ON-SITE SEWAGE DISPOSAL SYSTEM HOWARD COUNTY HEALTH DEPARTMENT BUREAU OF ENVIRONMENTAL HEALTH

SUBDIVISION: Windridge Farms' LOT NUMBER: 24

ADDRESS: 14511 Windridge Court PROPERTY OWNER: Selfridge Bldrs.

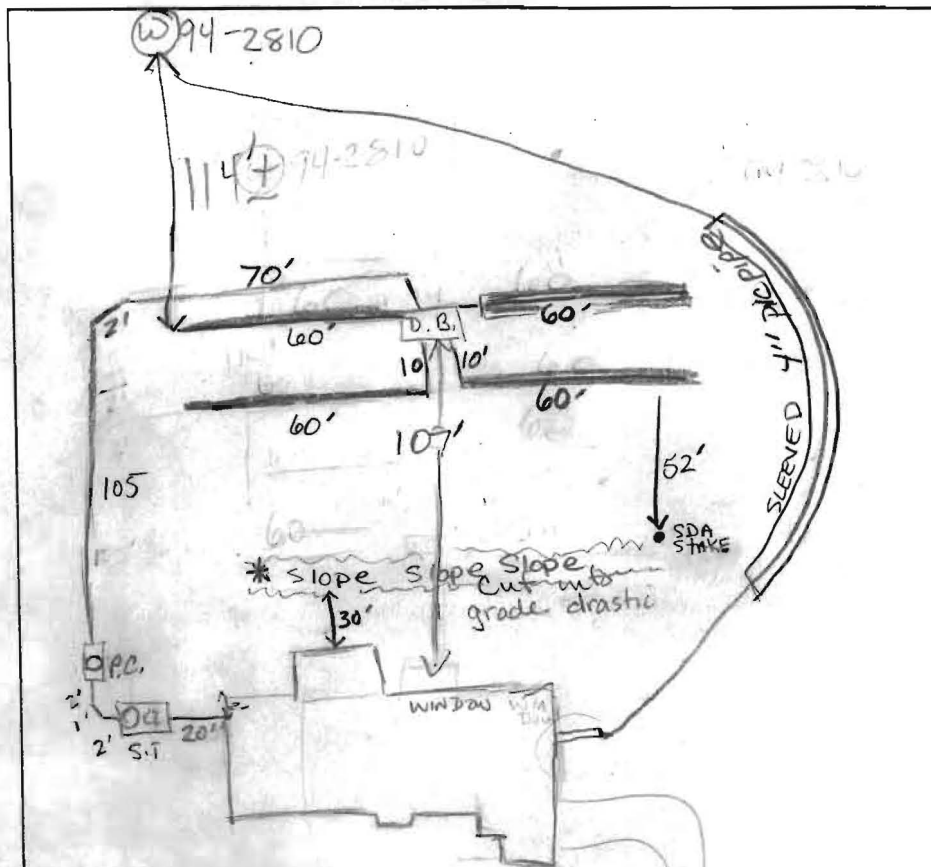
SEND LETTER
TO BUILDER
CONCERNING
LOSS OF 2500
S.R.A.
Future
Repairs?

* Downslope of SDA stakes closest to house is where a cut begins in SDA; bleed-outs could occur. Need 25' SETBACK Between any cuts and SDA. (KG/RP)

Approved Septic System Plan
Howard County Health Department

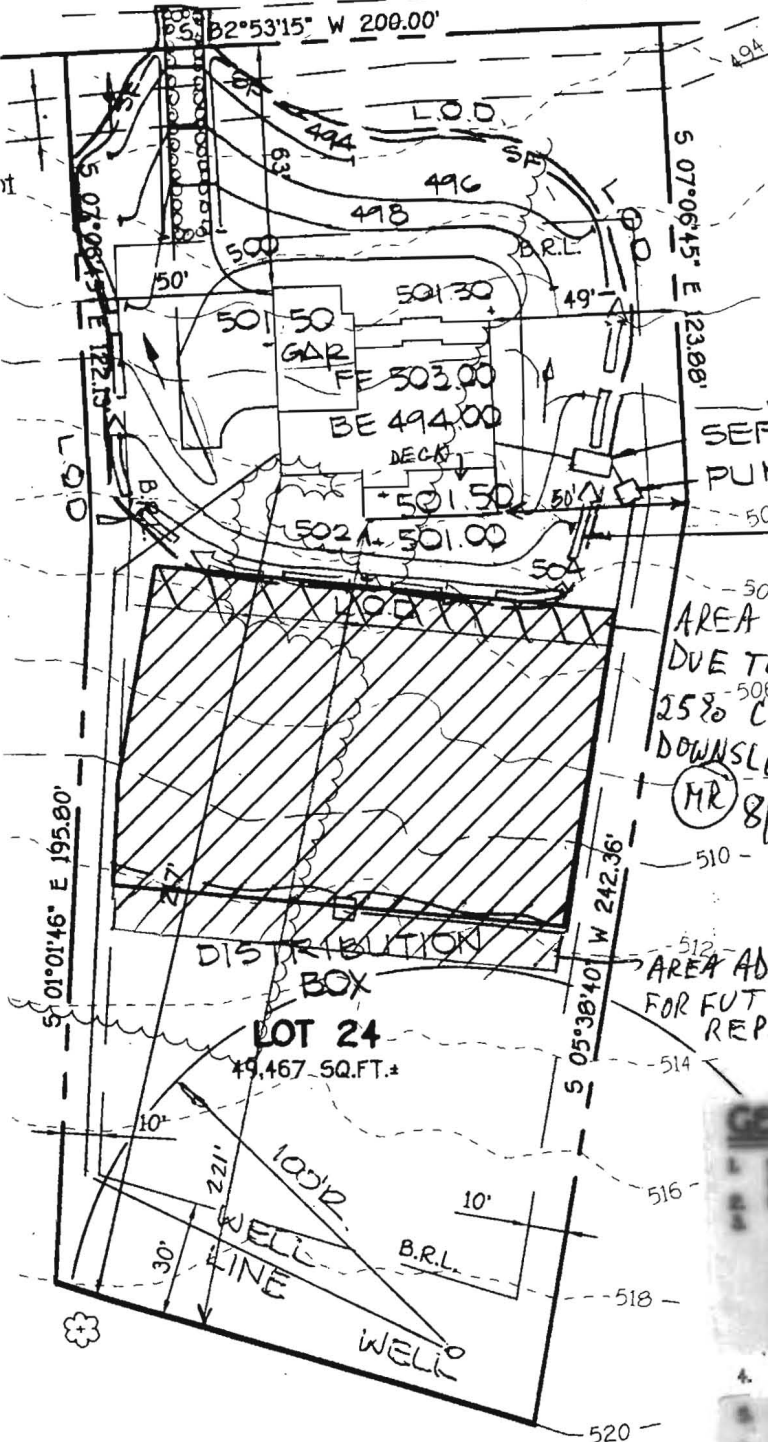
EARTH DIKE TYPE A-1
TO DIVERT CLEAN
WATER.

AREA DELETED
DUE TO 25%
CUT
DOWNSLOPE
